Access Compliance Report

Client: Penrith City Council, Cultural and Community Development Department

This report is for proposed Addition and Alterations to Existing building, the development being a building with classification as detailed below;

This development consists of an existing heritage building with meeting rooms a common meeting hall and associated works.

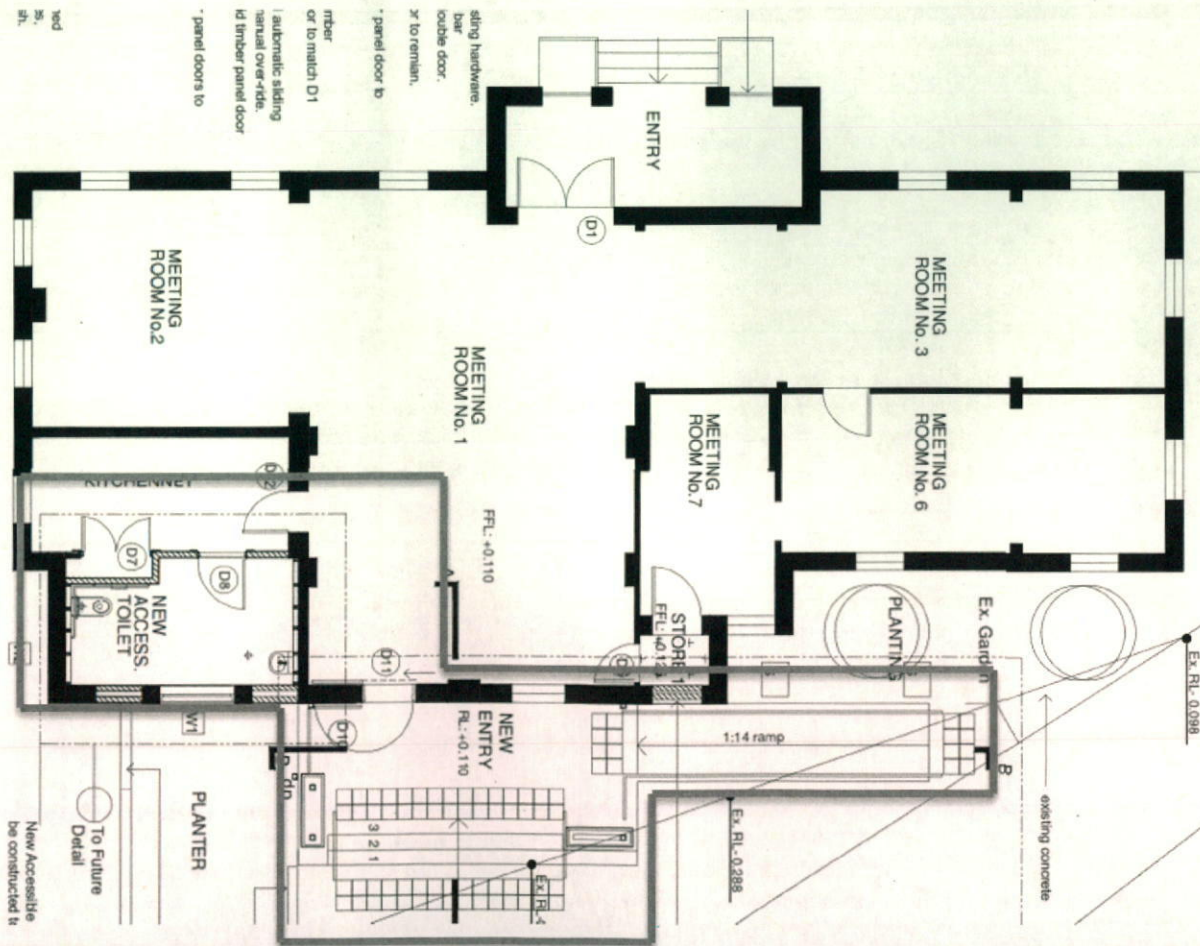
Compliance Comments	<p>Complies</p> <p>The building is an existing building and as such access is only required to the following areas,</p> <ul style="list-style-type: none"> - All new areas - All modified areas - All areas within the "affected part of works". <p>Affected part of works has been shown in red boundary on the plan below.</p> <p>The reminder of this report related only the areas which require access under the APS as described above.</p>

Figure 14 AS1428.1-2009

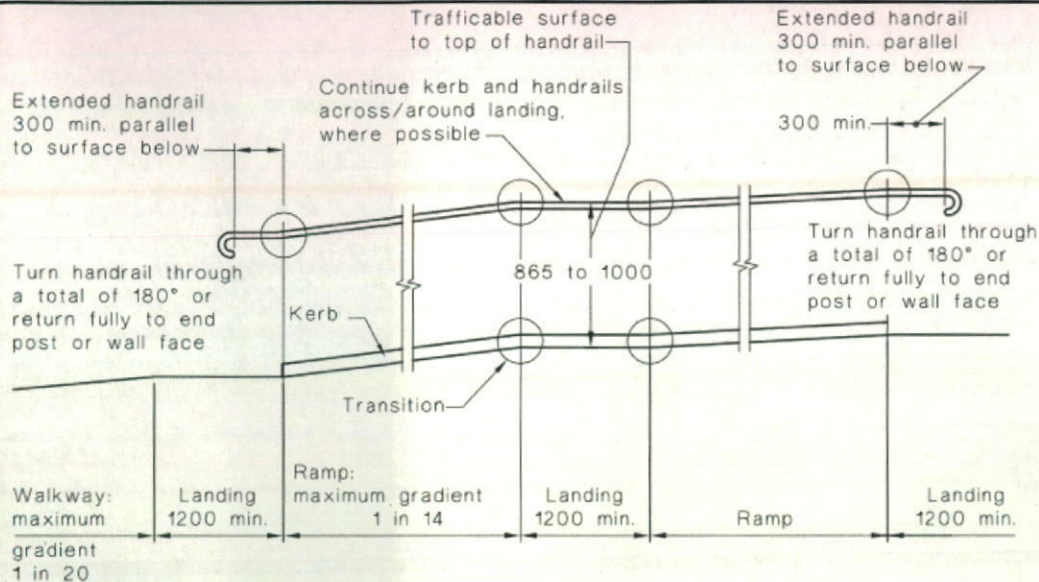
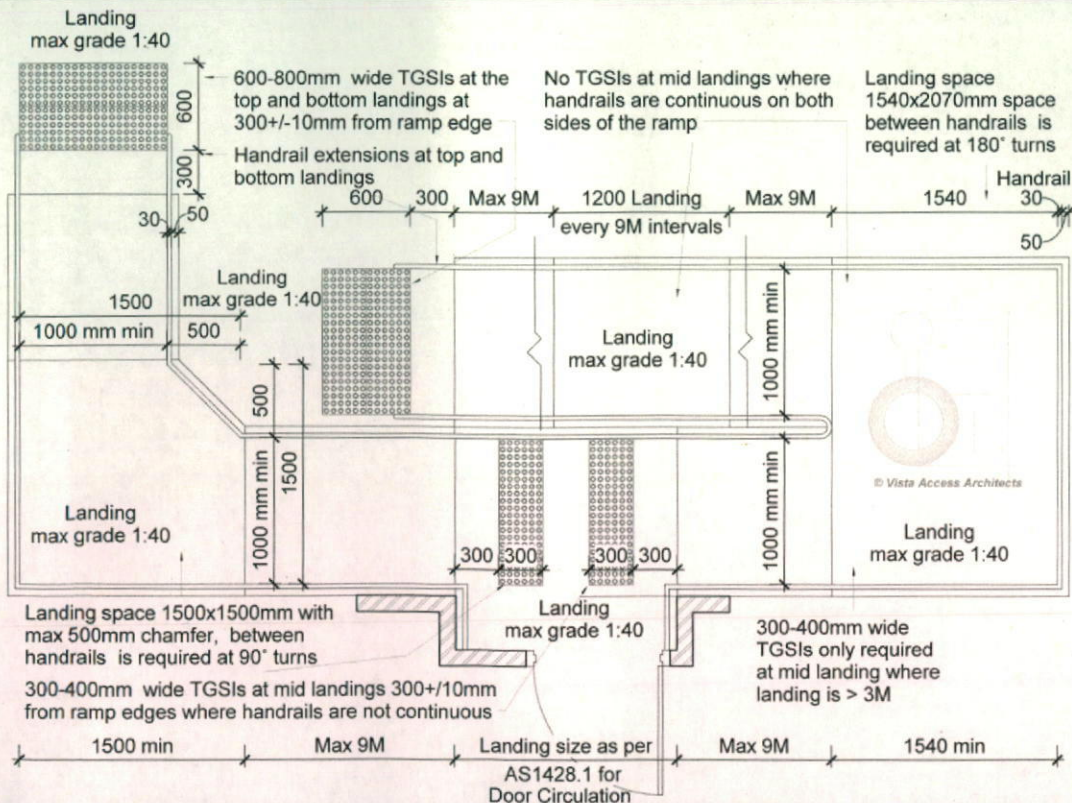
<p>BCA Part D3.3 Parts of buildings required to be accessible</p>
Requirement	<p>Every Ramp (excluding fire-isolated ramp) to be compliant with AS1428.1 including:</p> <ul style="list-style-type: none"> - Maximum gradient of 1:14 with 1.2M landings at top and bottom and at every 9M - At 90° turns a landing of 1.5x1.5M is required. 500mm chamfer to internal corner is permitted. - At 180° turns the depth of landing is to be a minimum of 1.54M (clear between handrails) - Where doors are provided on ramp landings, the landing size would also have to comply with the door circulation space requirements - Handrails to be provided on both sides with 1M clearance between them and located between 865-1000mm above FFL (finished floor level) with no vertical sections. - Diameter of handrails to be between 30-50mm (30mm preferred) and located not less than 50mm from adjacent walls with no obstructions to top 270° arc - Handrail to extend a minimum of 300mm horizontally past the transition point at the top

<p>and bottom of the ramp except where the inner handrail is continuous at an intermediate landing</p> <ul style="list-style-type: none"> - Kerbs / kerb rail to be provided on both sides, either minimum 65mm or 150mm above FFL and height not between 75-150mm above FFL with no gaps over 20mm within the same range - Slip resistance of ramps and associated landings to comply with BCA Table D2.14 when tested in accordance with AS4586. For 1:14 ramps, slip resistance of R11 / P4 should be provided (requirement under D2.10). Obtain Certificate stating that the Slip resistance complies with BCA requirements when tested as per AS4586.
Compliance Comments	<p>Capable of compliance. Add the above listed requirements to project specifications to ensure compliance</p>

Figure 26A AS1428.1-2009
Vista Access Architects Pty Ltd-
Reproduced under copyright Licence number 1501-c006-3

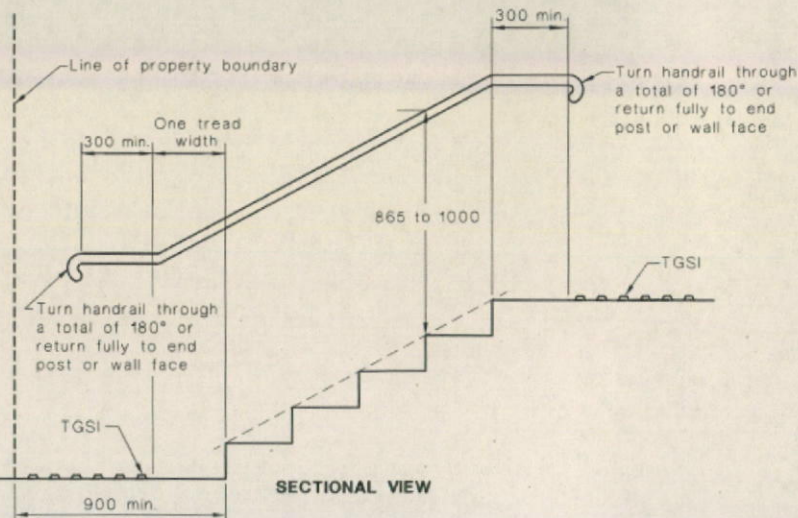
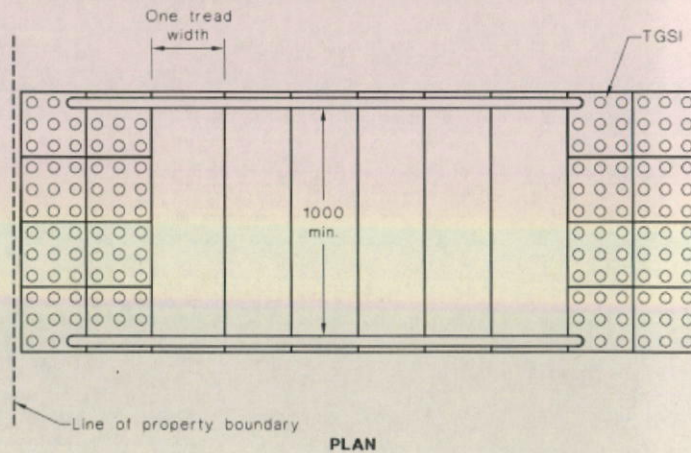
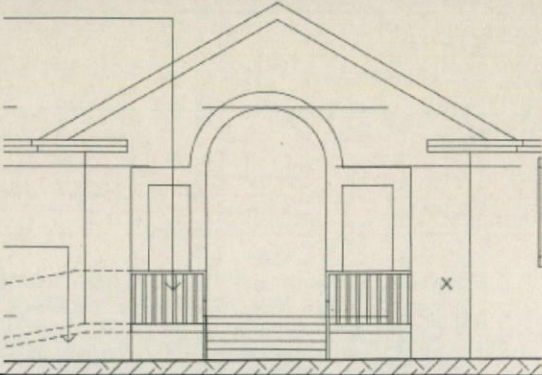
Requirement	Every Stairway (excluding fire-isolated stairway) is to be compliant with AS1428.1 including; <ul style="list-style-type: none"> - Stairs to have opaque risers with nosing to have a sharp intersection, or rounded or chamfered to 5mm - Each tread to have a nosing strip between 50-75mm for the full width of the stair, which can be setback for a maximum of 15mm from the front of the nosing. This strip is to have a minimum luminance contrast of 30% to the background and to comply with any change in level requirements if attached on the treads - Handrails to be provided on both sides with 1M clearance between them and located between 865-1000mm above FFL, with no vertical sections. Diameter of handrails to be between 30-50mm and located not less than 50mm from adjacent walls with no obstructions to top 270° arc - Handrails to extend a minimum of 300mm horizontally past the nosing on the top riser. At the bottom of the stairs the handrail is to extend at least one tread depth parallel to the line of the nosing, plus a minimum of 300mm horizontally from the last riser - Slip resistance to also comply with BCA Table D2.14 when tested in accordance with AS4586. For treads and landings, slip resistance of R11 / P4 and for nosing strips slip resistance of P4 should be provided (requirement under D2.13 and D2.14). Obtain Certificate stating that the Slip resistance complies with BCA requirements when tested as per AS4586. - Where doors are provided on landings, the landing size would also have to comply with the door circulation space requirements

Capable of compliance. Add the above listed requirements to project specifications to ensure compliance

These diagrams show some of the requirements for a LH transfer Accessible toilets as required by AS1428.1-2009.

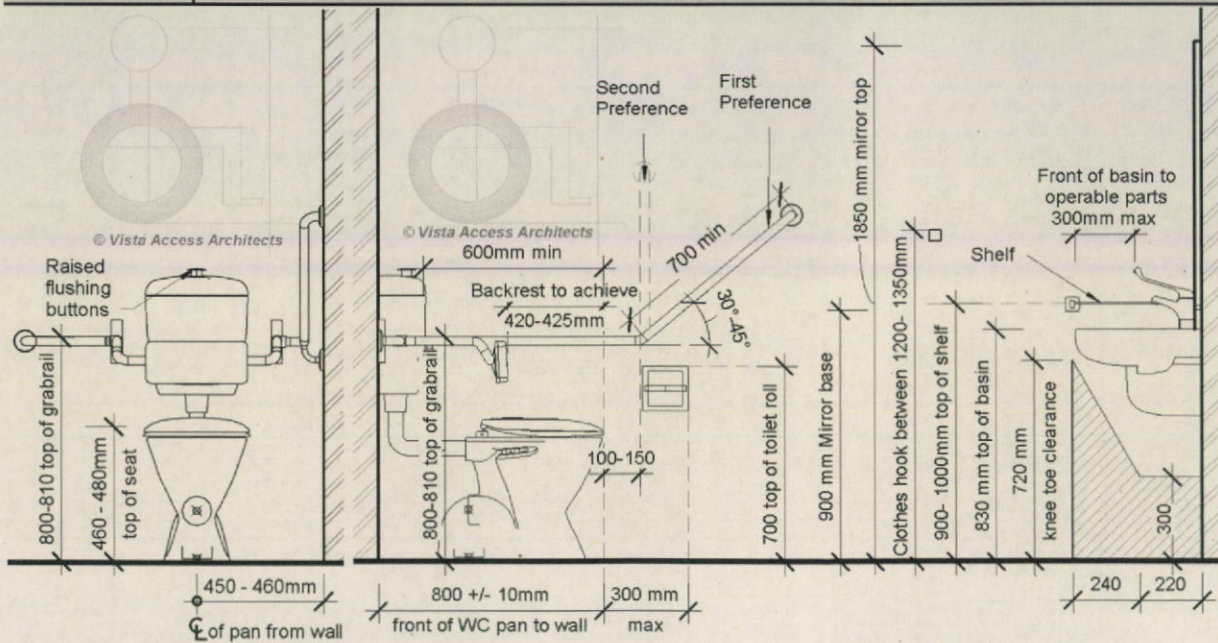
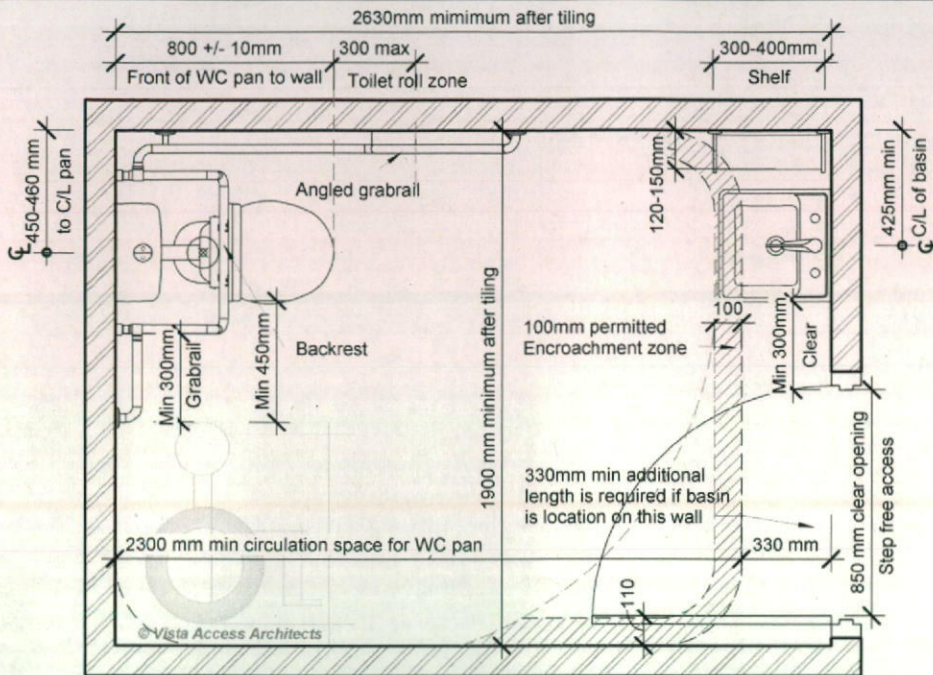
Requirement	Accessible unisex toilet are to be designed in accordance with AS1428.1
	<ul style="list-style-type: none"> - Floor is to be slip resistant - WC pan requires a circulation space of 1.9M(back of pan) x2.3M. Setout of pan is 800+/- 10mm from rear wall and the c/l of pan is to be 450-460mm from side wall. Top of seat of WC pan is to be 460-480mm above FFL - Wash basin requires an additional minimum 330mm when placed on opposite wall of pan and additional minimum 430mm when placed on adjacent side. The top of the washbasin is to be between 800-830mm above FFL. Water taps to be lever or sensor with 50mm clear from any surface - Seat to be full round, take 150kg weight and provide 30% luminance contrast to the background - Backrest to be 150-200mm height, 350-400mm width and 120-150mm above the seat at an angle of 95°-100° back from seat hinge - Flushing control to be proud of surface and located between 600-1100mm above FFL at back or side wall, clear of grabrail area - Top of toilet paper dispenser is to be located maximum of 700mm above FFL and maximum of 300mm from edge of pan - Grabrails, 30-40mm diameter, placed 50-60mm clearance from wall, with no obstructions to top 270° arc, are to be provided to rear and side wall (90° or 30° - 45°). Horizontal component to be 800-810mm above FFL. Fastenings and construction of grabrails to be capable to withstand 1100N of force. 30° - 45° grabrails are preferred. - Mirror to start from 900mm above FFL, till minimum of 1850mm above FFL - Clothes hanging device to be at height of 1200-1350mm above FFL and at least 500mm from any internal corner - A portable sanitary waste disposal unit to be provided - Shelf is required to be either integrated or as a separate fixture 300-400mm length and 120-150mm wide and located 900-1000mm above FFL - Baby change tables where provided cannot encroach into the circulation space and have a maximum height of 820mm with 720mm underneath when in open position - Soap and paper towel dispensers where provided, to be installed with height of the operative component between 900-1100mm above FFL and no closer than 500mm from an internal corner. - Door to the Accessible toilet requires AS1428.1 compliant door circulation spaces. When door swings next to the washbasin a clear 300mm is required between the door swing and the washbasin. Select the washbasin so that it complies with this requirement.

Compliance Comments	Capable of compliance with the width and length requirements, based on selected fixtures. Add the above listed requirements to project specifications to ensure compliance.

Please note that the size of the basin will have an effect on the minimum size of the toilet due to the 300mm clear space required from door swing to the edge of the basin as well as the maximum permissible 100mm encroachment in the 2300mm circulation space

Door circulation requirements

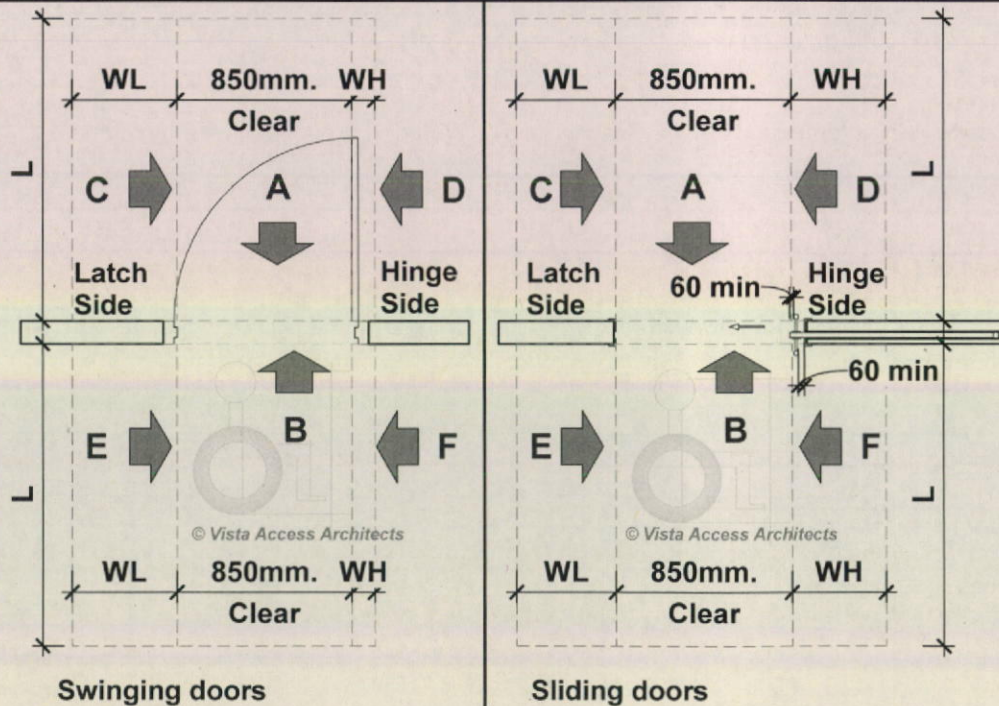
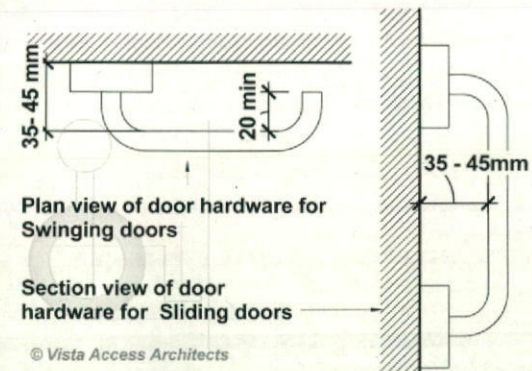
Requirement	Doorway requirements <ul style="list-style-type: none"> - All doorways in the development to have a clear opening of at least 850mm with appropriate door circulation spaces in accordance with AS1428.1 - Door thresholds are to be level or they can incorporate a Threshold ramp with a maximum grade of 1:8, for maximum rise of 35mm and a maximum length of 280mm and located within 20mm of the door leaf, with edges to be tapered or splayed at a minimum of 45° where it does not abut a wall. - Distance between successive doorways in airlocks to be 1450mm which is measured when the door is in open position in case of swinging doors.
--------------------	---

For surface mounted sliding doors, circulation space on the opposite side of the door face will increase by the value of the wall thickness to the face of the door.

Compliance Comments	Capable of compliance. Add the above listed requirements to project specifications to ensure compliance.
Requirement	Door hardware requirements; <ul style="list-style-type: none"> - D shaped door handles to be used, located at 900-1100mm above FFL - Clearance between the handle and the back plate or the door face at the center grip section of the handle to be between 35-45mm with a minimum of 20mm turn at the end of the handle - Where door to the Accessible WC swings out a door closer will be required. Where a door closer is fitted, (excluding fire door) the force required at the door handle to operate the door is not to exceed 20N - Manual control to power operated door to be push button type control with a minimum diameter of 25mm, proud of the surface and located a min of 500mm from an internal corner and between 1M- 2M if hinged door is used - Where snibs are installed in accessible sanitary facility doors, they are required to have a lever handle of a minimum length of 45mm from the center of the spindle
